Mag wiring schematics are taken from Z-20. Quotes are from Note 3. I drew a line between the shield 'hoop' at the switch and the 'hoop' at the mag to signify its electrical connection to what I hope is the engine block (or maybe the mag case connected to the block). My markups are otherwise in red and green...I hope!

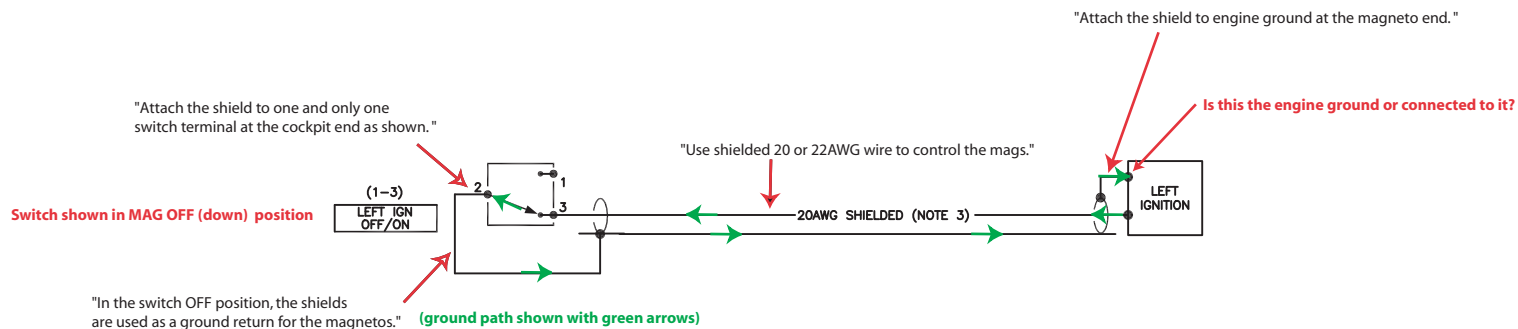
"In the MAG ON position, the shields are protection from electrostatic coupling of magneto noise. The shields should not be attached to any form of ground at the panel, just the magneto switch."
